PROJECT TITLE: **OSCC ORANGE HALL THEATER
HVAC UNIT REPLACEMENT**
COUNTY JOB NO.: OSCC-2023-20

SKETCH TITLE:
RETAINING WALL CLARIFICATION

SKETCH No:
SKHE-100.1

ISSUE DATE:
11/03/22

MECHANICAL/ELECTRICAL CONSTRUCTION SITE PLAN

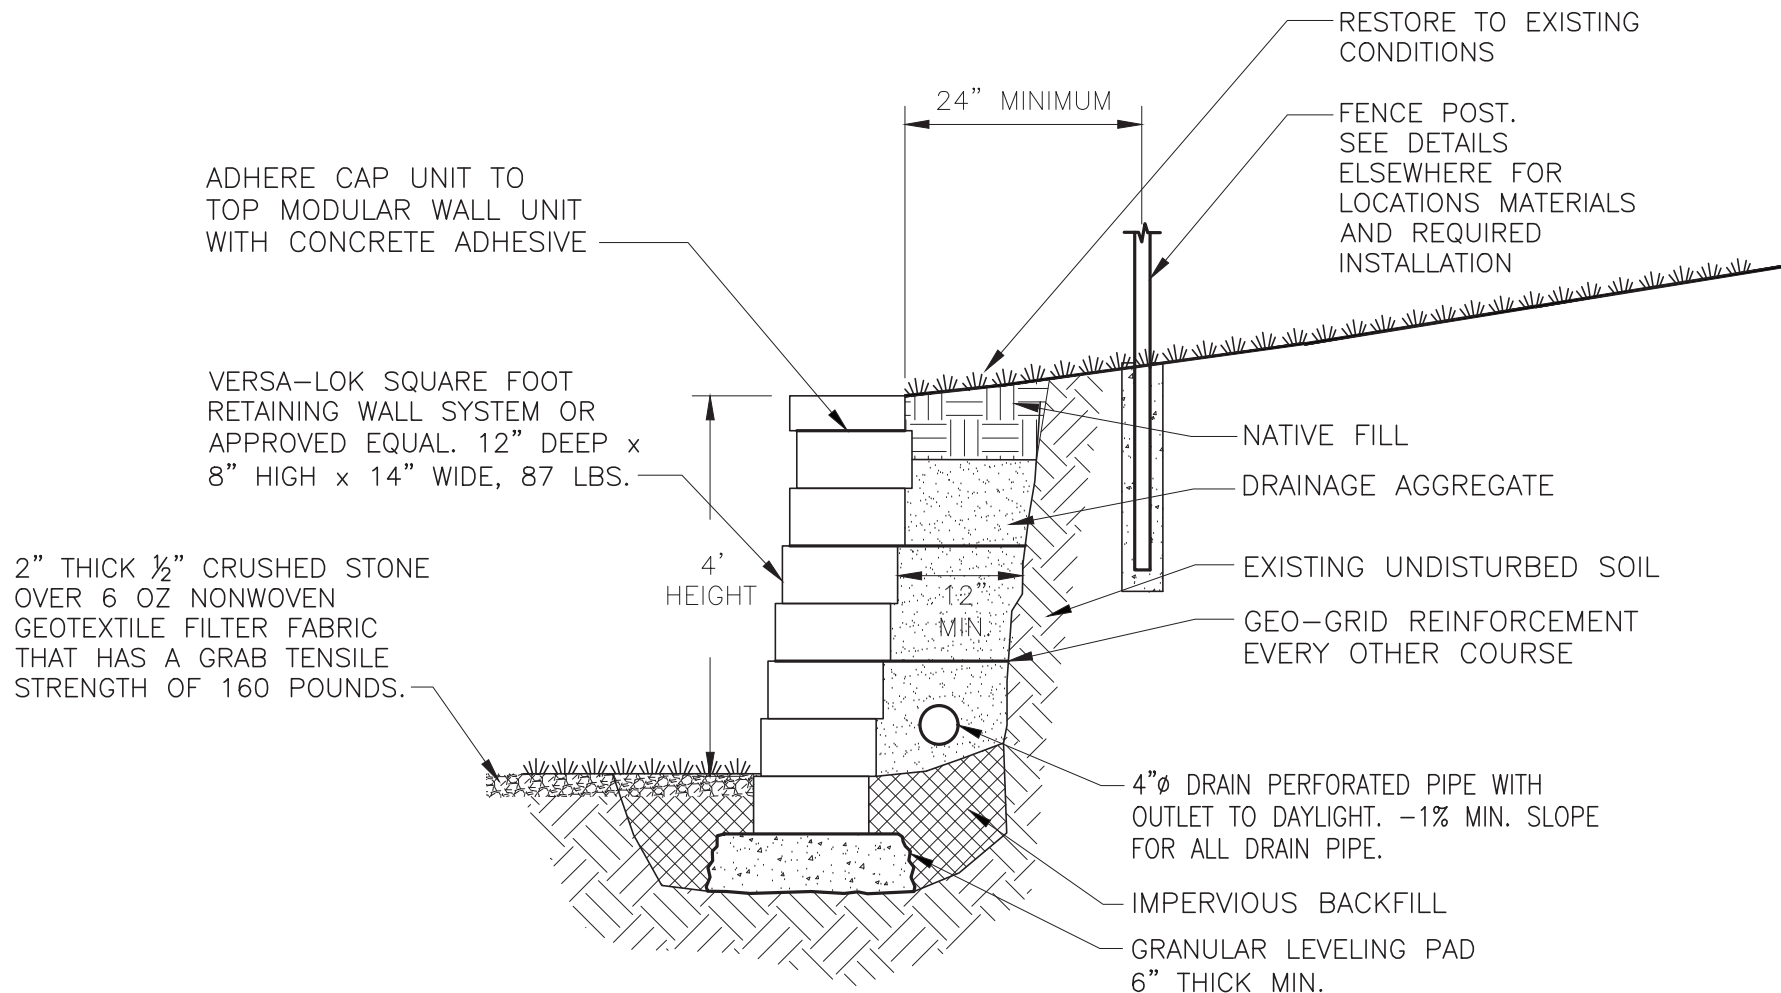
STEP WALL FROM
4' HIGH TO
1' HIGH
AS REQUIRED

4' HIGH
RETAINING WALL

PERFORATED RETAINING
WALL DRAIN PIPE WITH
OUTLET TO DAYLIGHT

PROVIDE NEW RETAINING WALL.
SEE DETAIL 5/HE-701

EXCAVATE AREA FOR NEW RETAINING WALL.
REMOVE ALL MATERIALS OFFSITE AND
RESTORE EXISTING AREAS.
